31/07-04H 10210 Menlo Ave
Capitol View Historic District

1 THE MARYLAND-NATIONAL CAPITAL PARK AND PLANNING COMMISSION
2 HISTORIC PRESERVATION COMMISSION

- 3 - - - - - X
- 4 HISTORIC AREA WORK PERMIT - : HPC Case No. 23/57-05A
4501 Olney Laytonsville Road :
5 :
6 - - - - - X
- 6 HISTORIC AREA WORK PERMIT - : HPC Case No. 31/07-04H
7 ~~10220~~ Menlo Avenue :
8 **10219** :
9 - - - - - X
- 9 HISTORIC AREA WORK PERMIT - : HPC Case No. 31/06-05D
3920 Baltimore Street :
10 :
11 - - - - - X
- 11 PRELIMINARY CONSULTATION - : Clarksburg Historic
12 23310 Frederick Road : District
13 :
14 - - - - - X

Circle 4

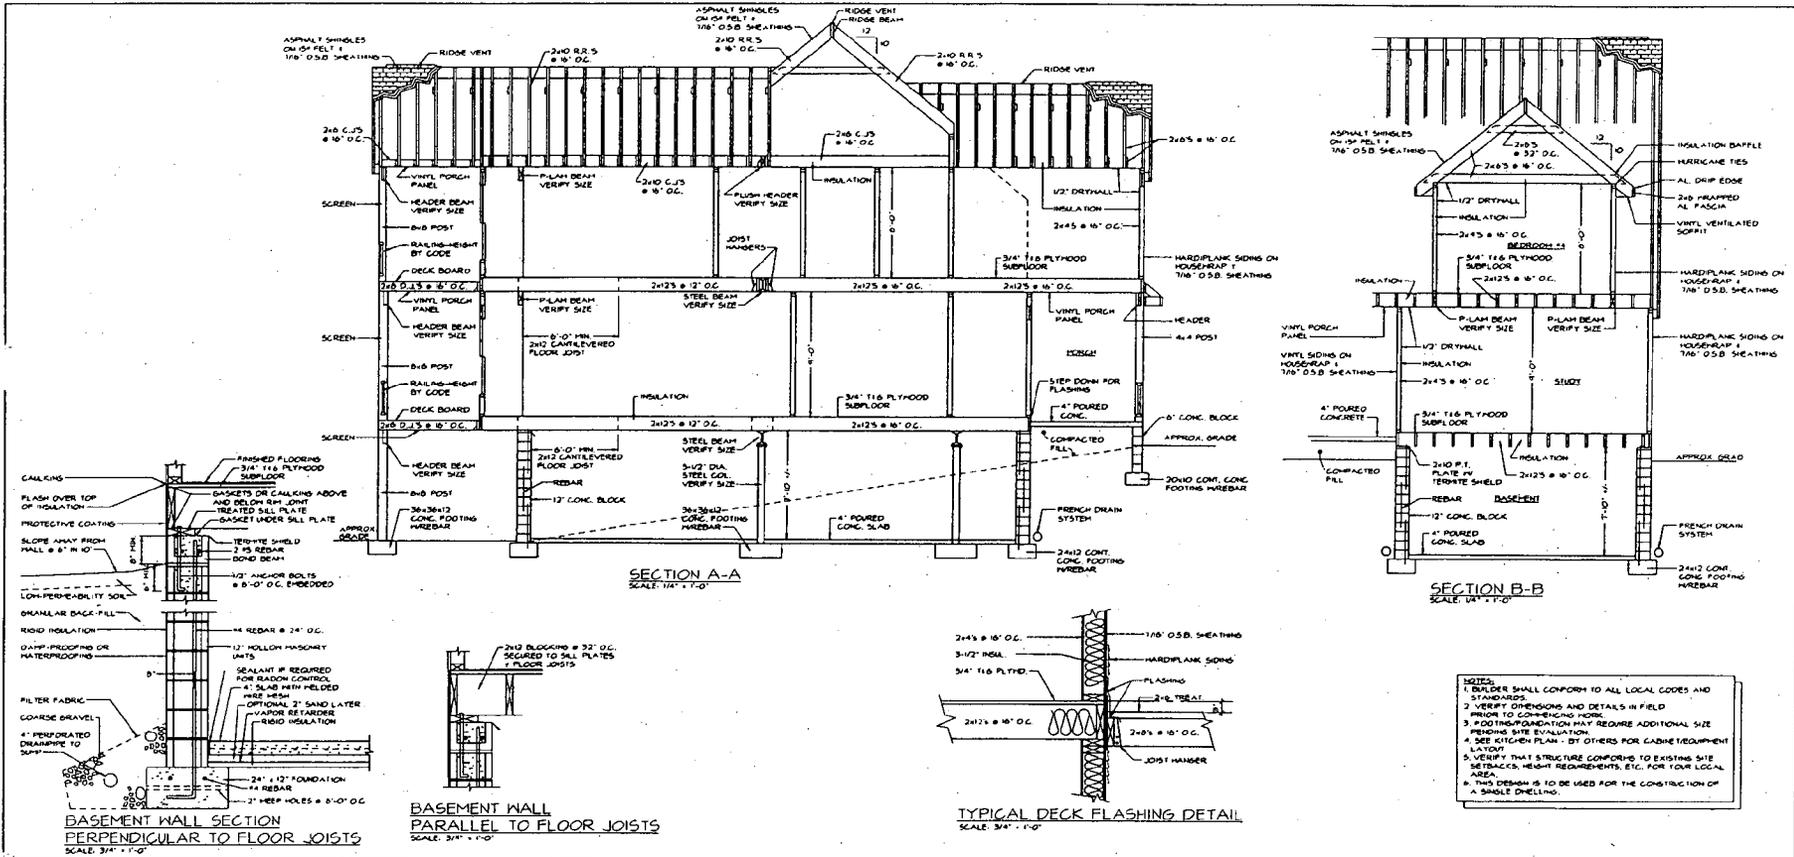
Must come back as HAWP

Also must explore maintenance of access to the adj historic site.
Perhaps a shared driveway

REVISED 5/25/05

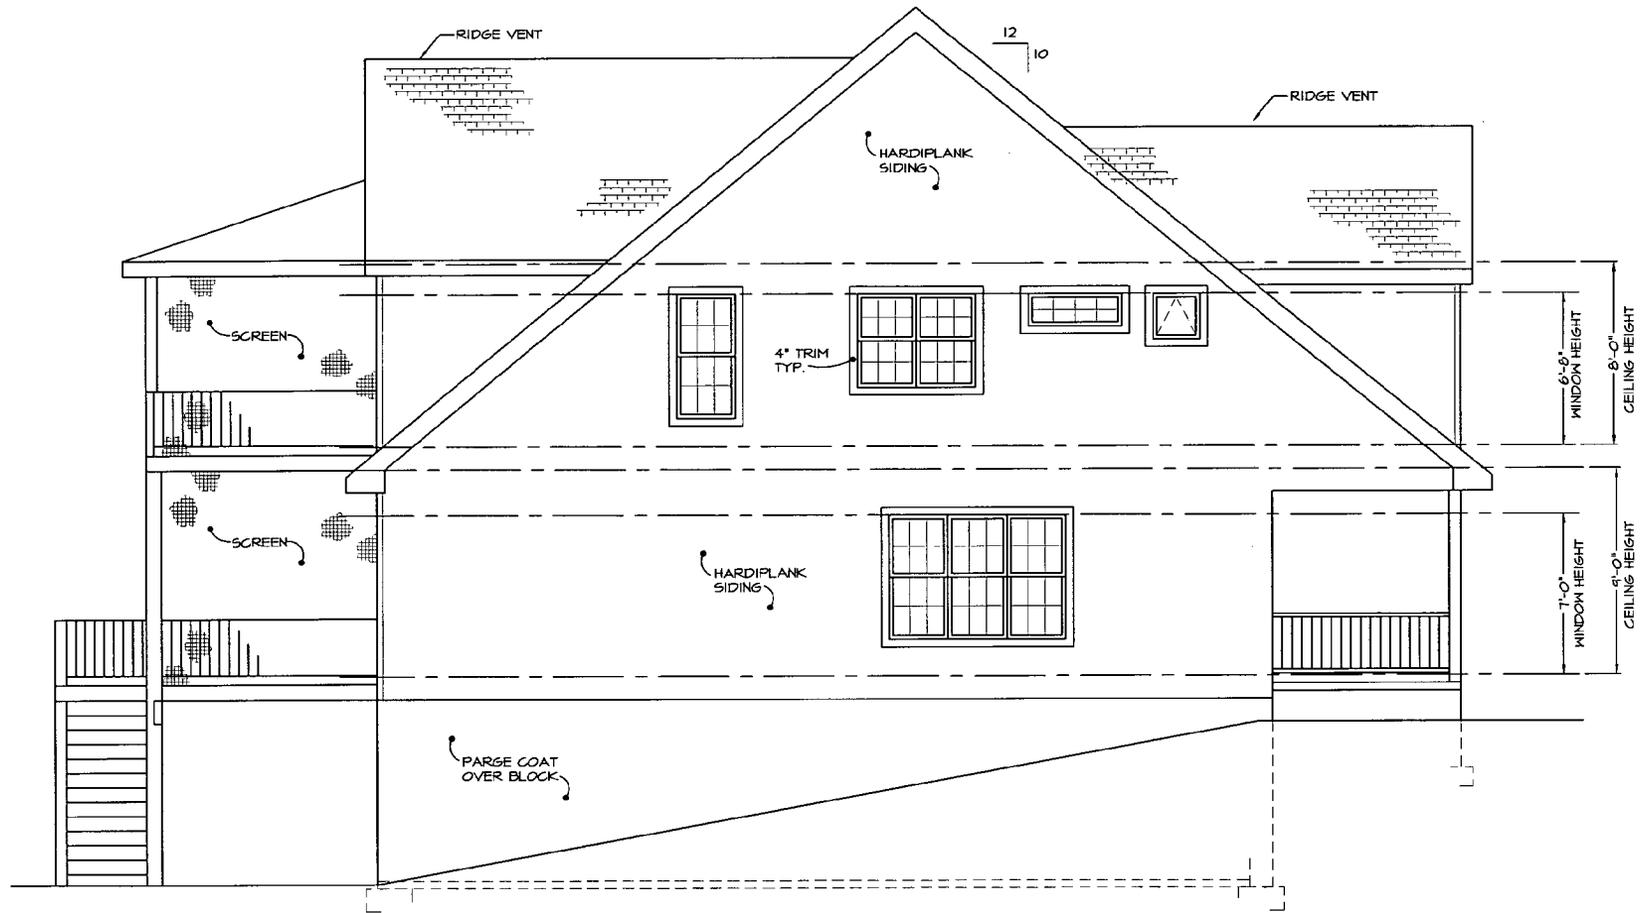
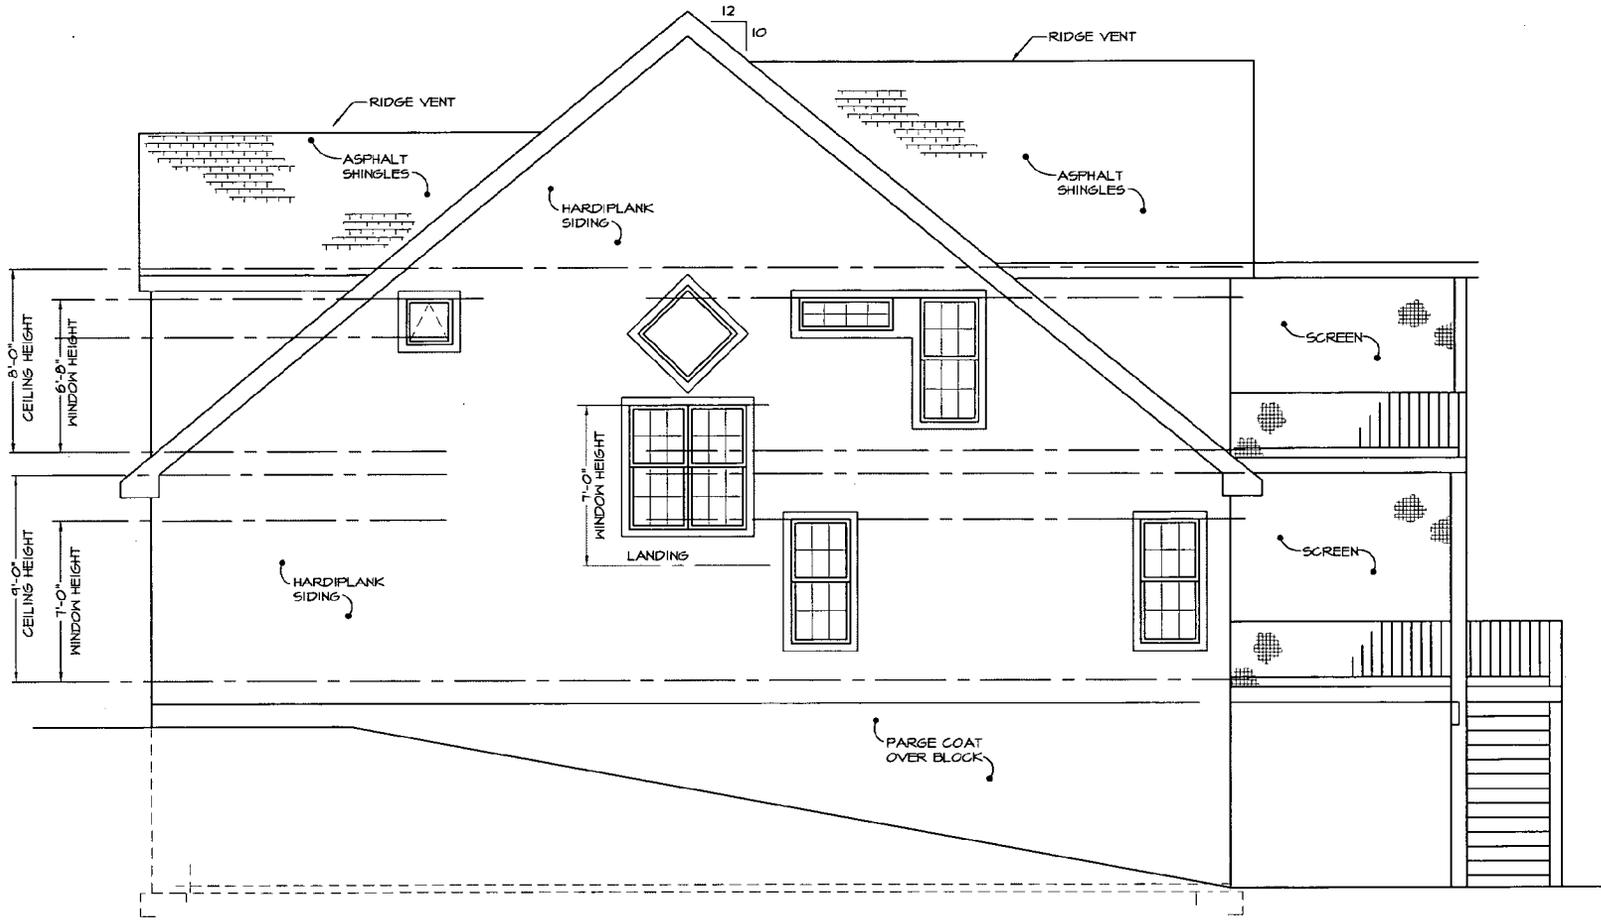
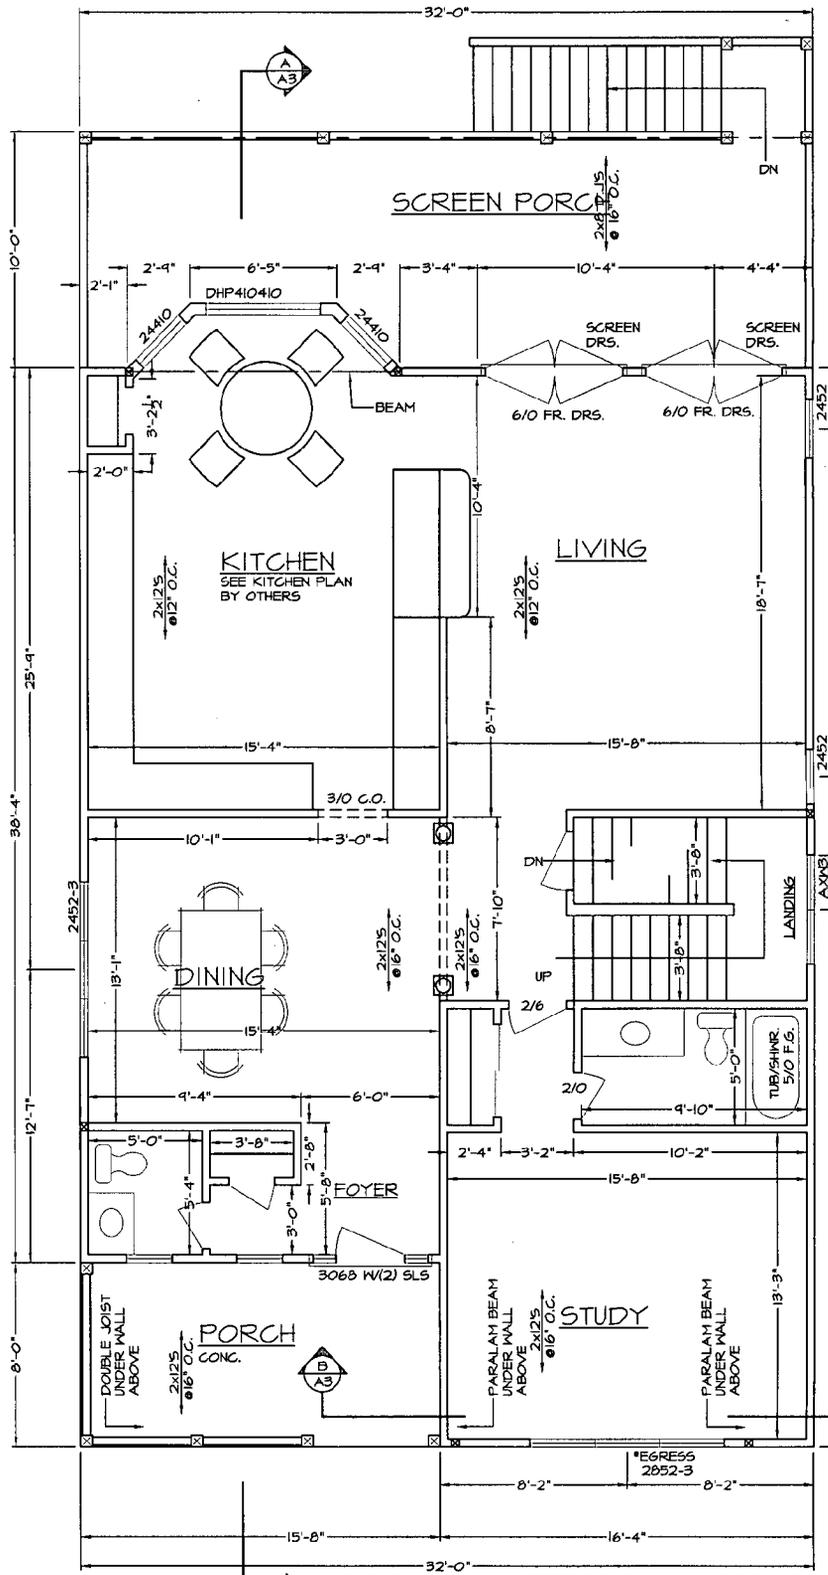
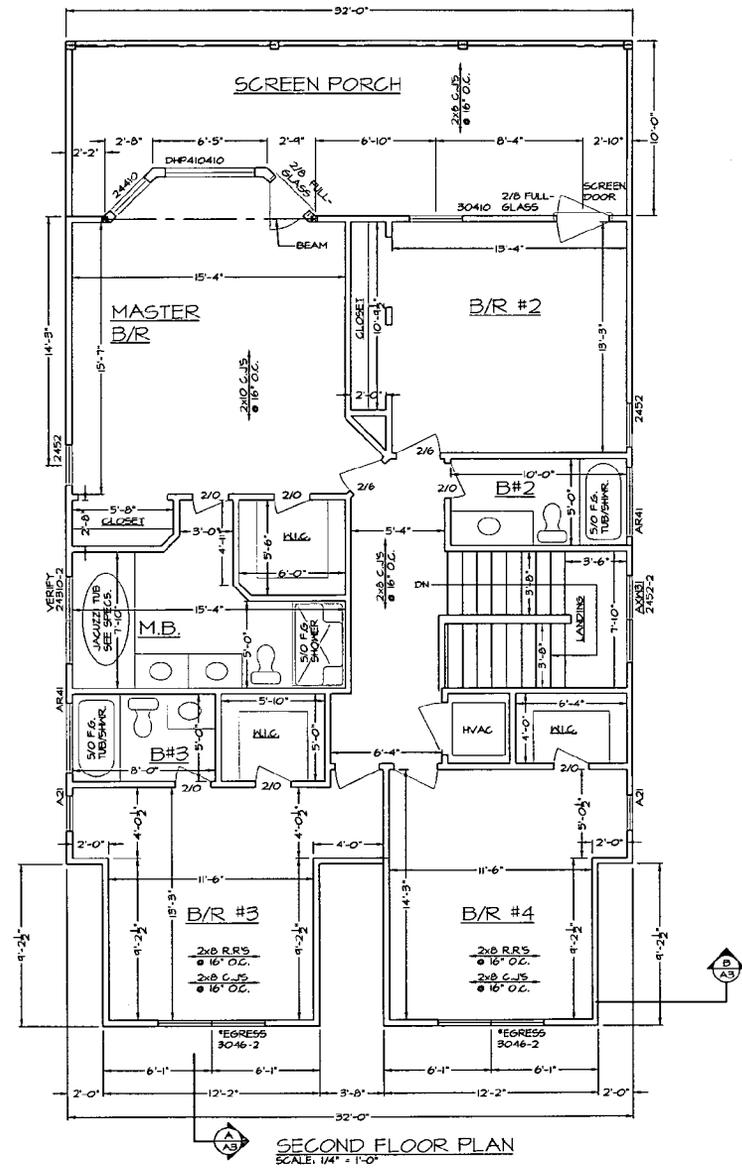
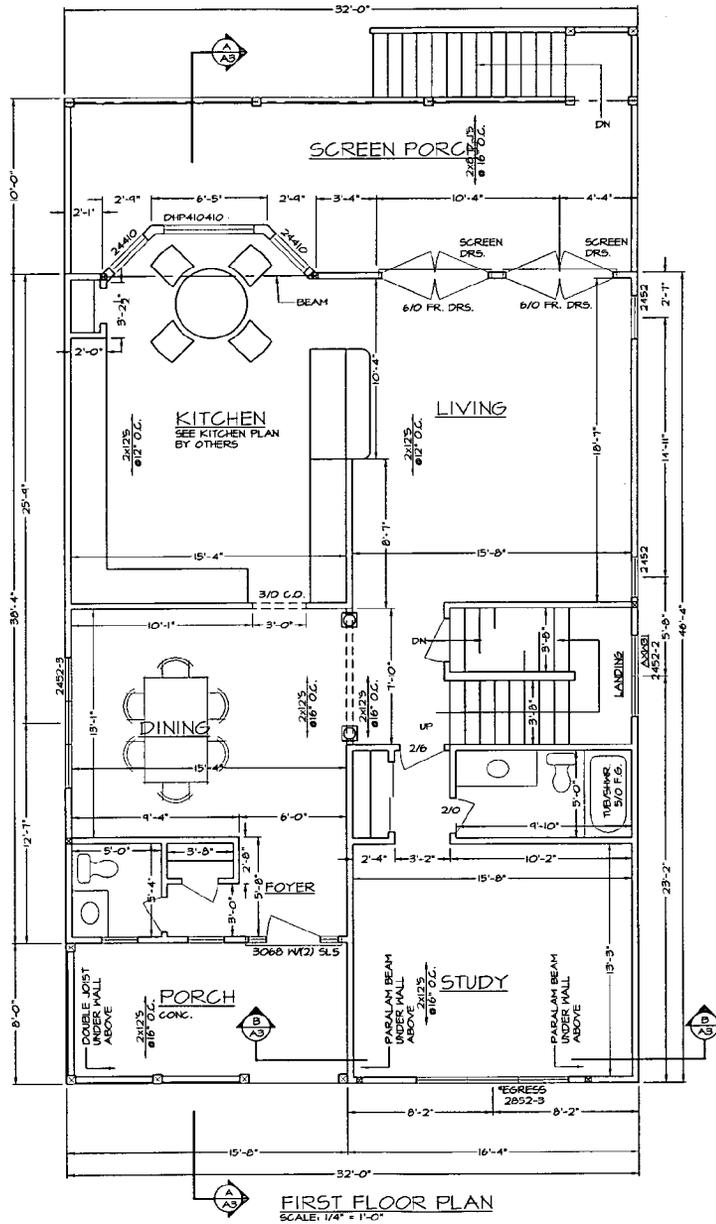
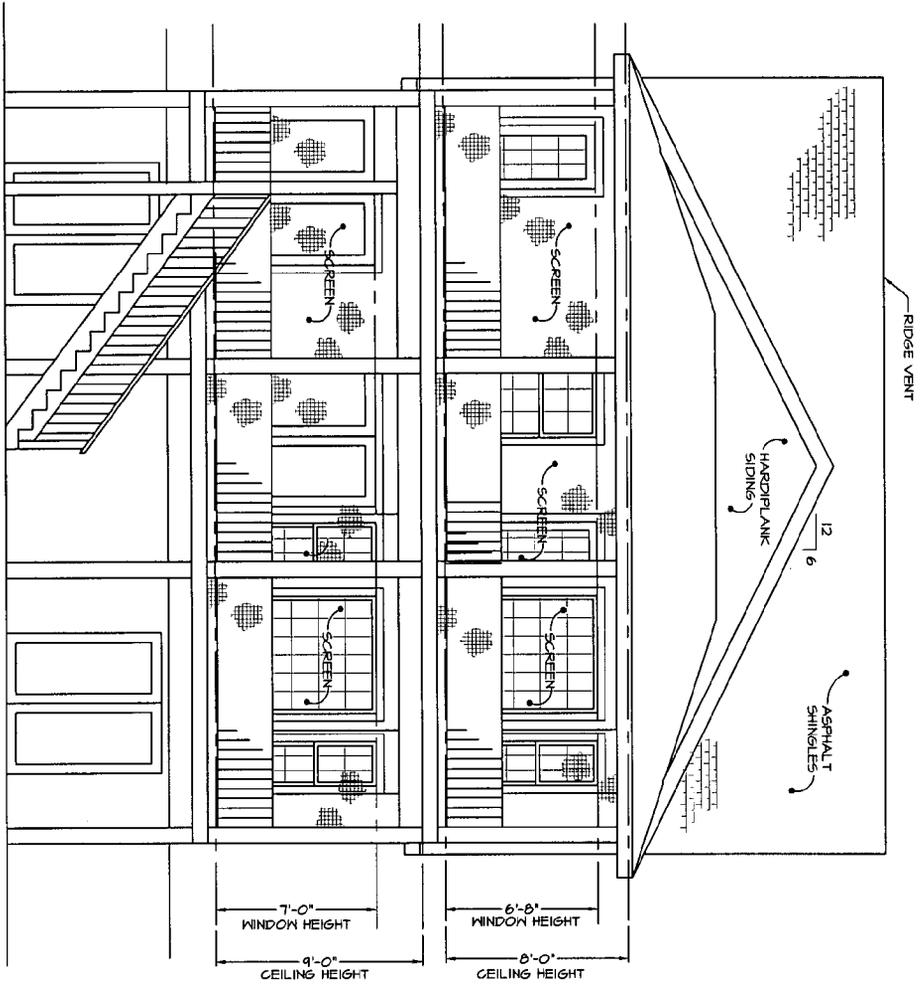
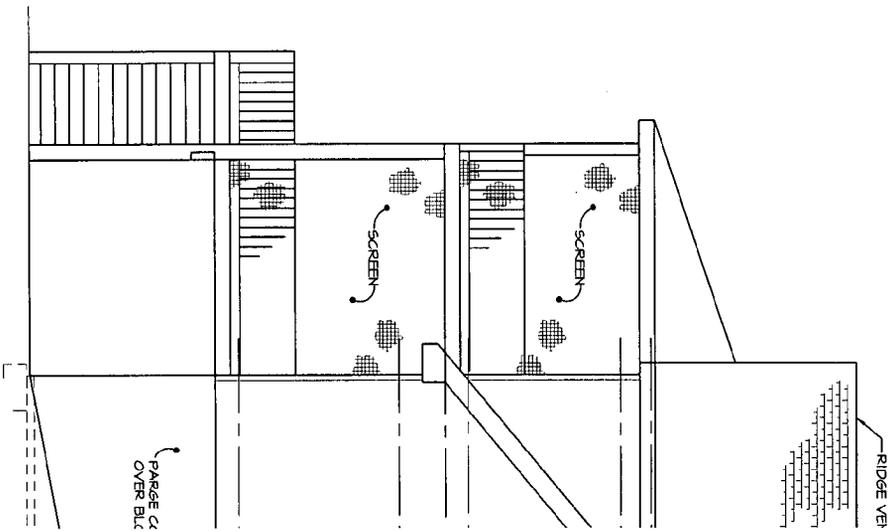
7. Tree protections measures are in place prior to beginning of any work to protect trees on the Lange House property. **NEED SITE PLAN SHOWING LOCATION OF TREE PROTECTION BARRIERS**

8. The applicant will present 3 permit sets of drawings to HPC staff for review and stamping prior to submission for permits **OK TO HAVE THESE MADE**
9. Revised elevations drawings will be provided to and approved by staff prior to the completion of construction documents. **DONE**

REVISED 5/25/05

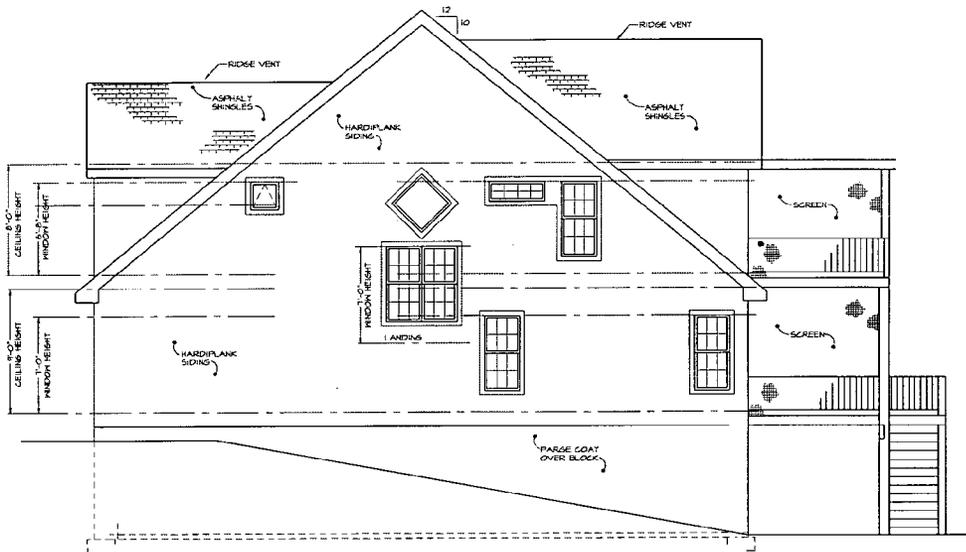
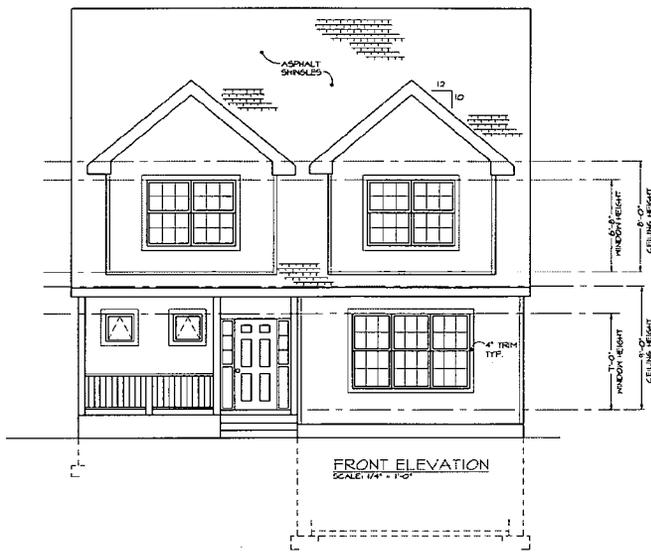
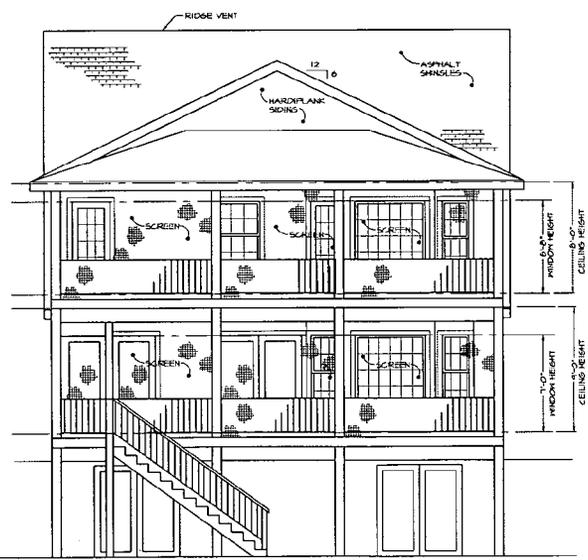
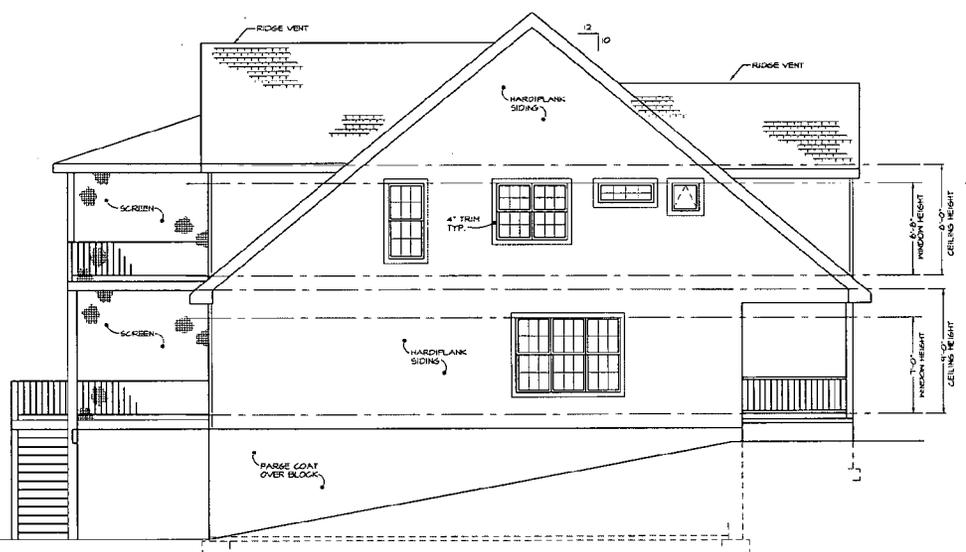
We need detail drawings of the porch rails and columns
